Inner Sydney High School (SSD 7610): Section 4.55(1A) Modification Application

Inner City High School (SSD 7610 MOD 4) - Relocation of Drop-off / Pick-up Facility

Figure 1: Revised Drop off/Pick up Zone location on western side of Chalmers Street

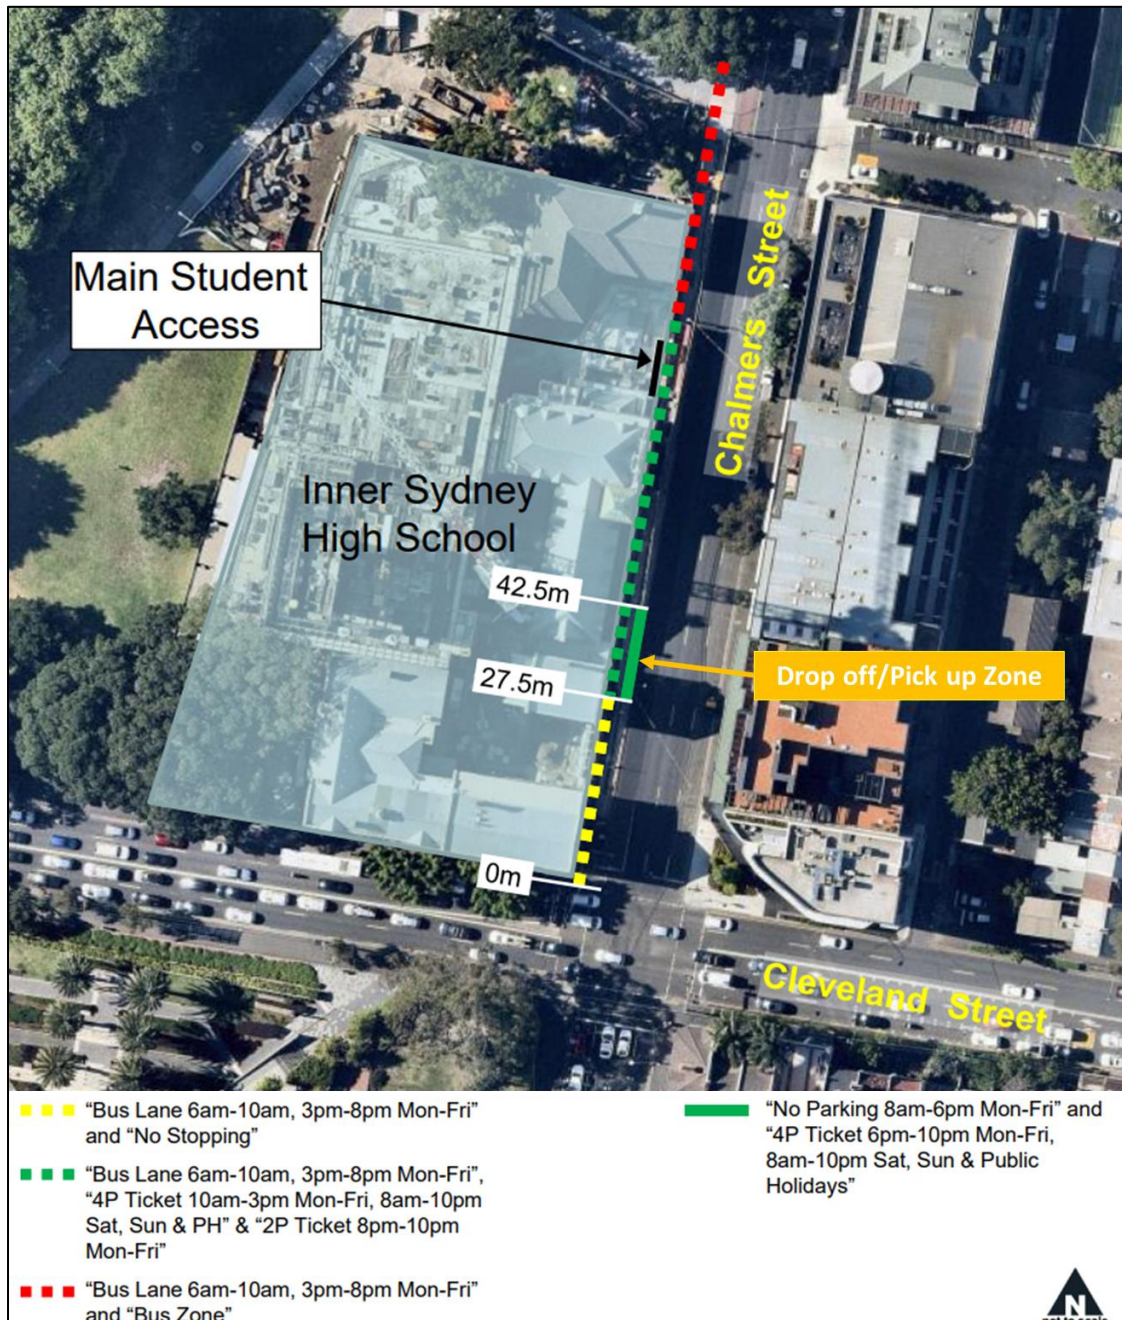
Council, in consultation with TfNSW, identified an alternative location for the school drop-off / pick-up zone on the western side of Chalmers Street directly adjacent to the school grounds (see **Figure 1**). It is noted that the use of this area requires the removal of part of

an existing bus lane which operates 6.00am - 10.00am and 3.00pm – 8.00pm Monday - Friday. Outside of these hours, the area is available for ticketed parking.

DoE requests that Condition D4 be amended to reflect Council's position in relation to the drop-off / pick-up zone, namely, relocating the facility to the 17.7 metre long "No Parking" zone on the western side of Chalmers Street (which has the support of TfNSW).

- D4. **The Applicant must utilise the 'No Parking Zone' on the western side of Chalmers Street adjacent to the school as approved by Council's Local Pedestrian, Cycling and Traffic Calming Committee on 12 December 2019 for use as a drop-off / pick-up facility for students, unless otherwise agreed by the Secretary.**

Figure 1 – Sydney City Council Approved Drop Off / Pick Up Facility Location & Length

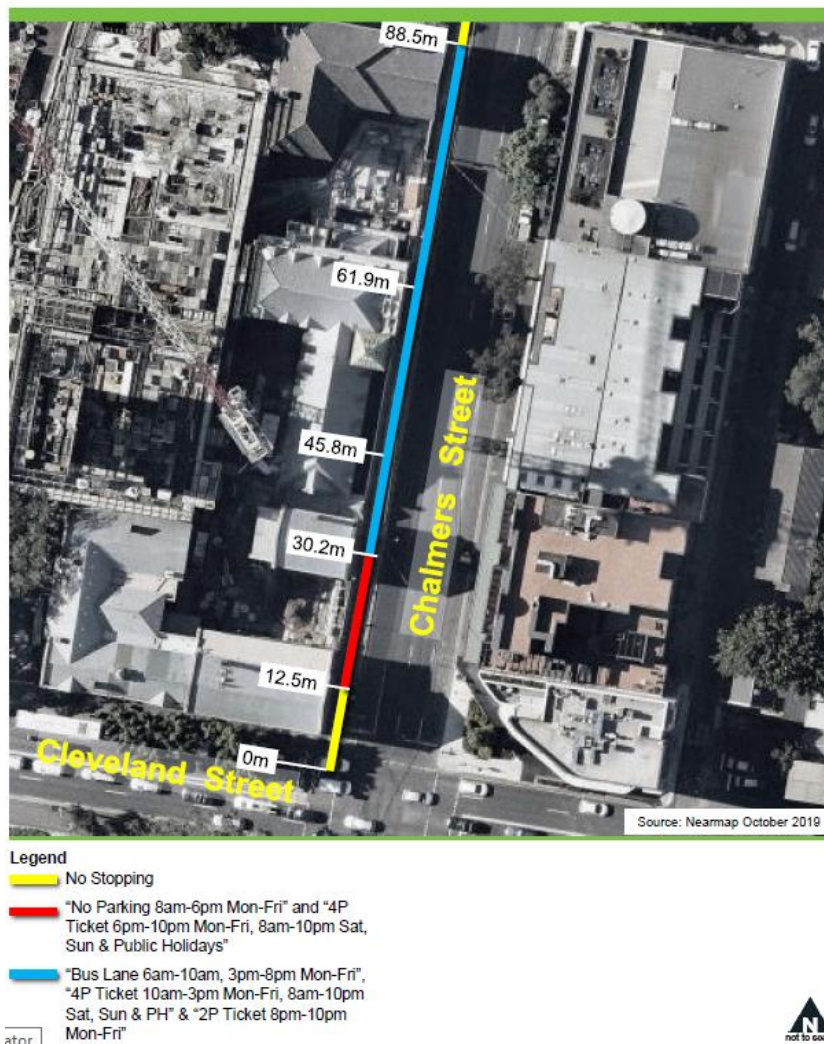
It is noted that the Sydney City Council approved "No Parking" zone on the western side of Chalmers Street has a length of **17.7m** as shown below from the sketch plan prepared by Sydney City Council.

Whilst Council's approval was based on a capacity of **2 cars** within the **17.7m** long Drop-off / Pick-up facility (in the form of a No Parking Zone). The actual capacity of this space is **3 cars** based on current Australian Standards for the provision of parallel parking spaces.
